**STAFF REPORT
HISTORIC AND CULTURAL LANDMARKS COMMISSION
CITY OF FORT WORTH, TEXAS**

DATE: January 9, 2023

REQUEST	Certificate of Appropriateness
APPLICANT/AGENT	Bennett Partners/US Energy Development Corp
LOCATION	601 E. Exchange Ave.
ZONING/ USE (S)	SY-HCO-55/HC
NEIGHBORHOOD ASSOCIATION	Stockyards

Figure 4. Proposed site plan

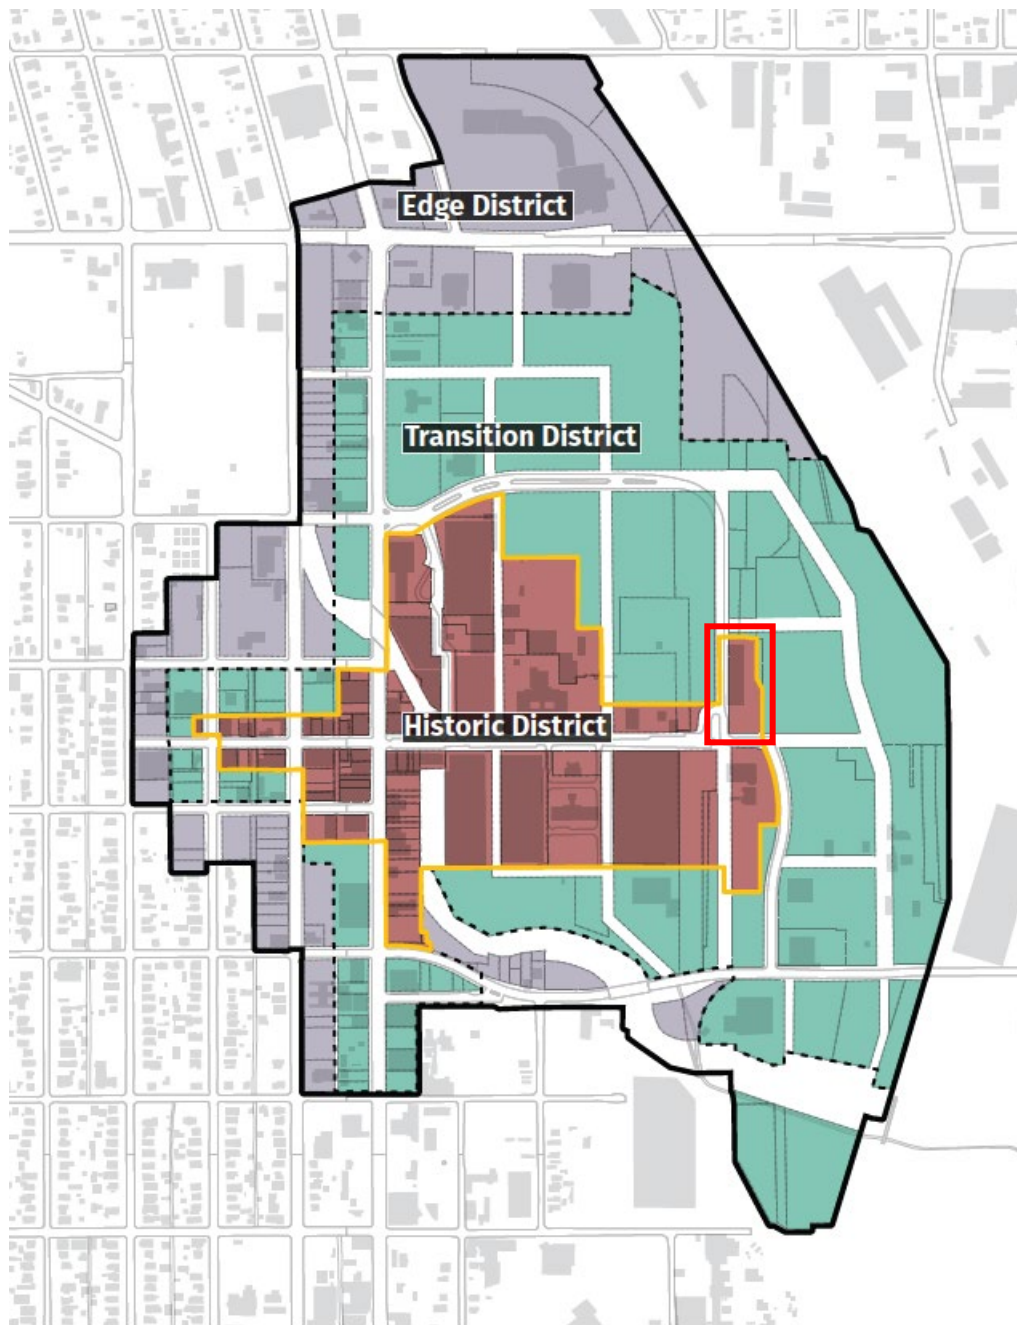
The applicant is seeking a waiver to construct the surface parking with a 20' setback instead of the required 30' setback, and to install the painted sign on unpainted masonry.

In the Stockyards Form-Based code, the building is located on the Pedestrian Frontage along Stockyards Blvd and E Exchange Ave which requires a 30' parking setback. The proposed office use would typically require 2.5 off-street parking spaces per 1,000 square feet of gross floor area according to the Zoning Code. However, since the structure is located in a local Historic and Cultural (HC) District and in a National Register of Historic Places district, the site is exempt from off-street parking requirements.

The building is located very close to Stockyards Blvd. The requested setback still allows for the creation of an outdoor space for the building users, and relief from the street to create a better pedestrian experience along Stockyards and E. Exchange Avenue. The applicant proposes to provide substantial screening of the parking lot using landscaping, trees, sidewalk and fencing to compliment the Old Swift Office Building across Exchange Avenue and continue the Exchange streetscape. The proposal also references traditional landscaping of the Armour Headquarters building, which is no longer extant, thereby reestablishing a traditional landscape at this important intersection. Given the proposed mitigation, the waiver is supportable. The applicant will need to finalize streetscape and pedestrian access plans with staff before final approval of all plans.

That the request for a Certificate of Appropriateness for waivers from the Stockyards Form-Based Code and Design Guidelines for a 20' parking setback be approved with the following conditions:

1. That the applicant continue to work with staff on the treatment of the pedestrian and street requirements, and;
2. That any adjustments made to the drawings be submitted to the Development Services Department prior to the issuance of a Certificate of Appropriateness.
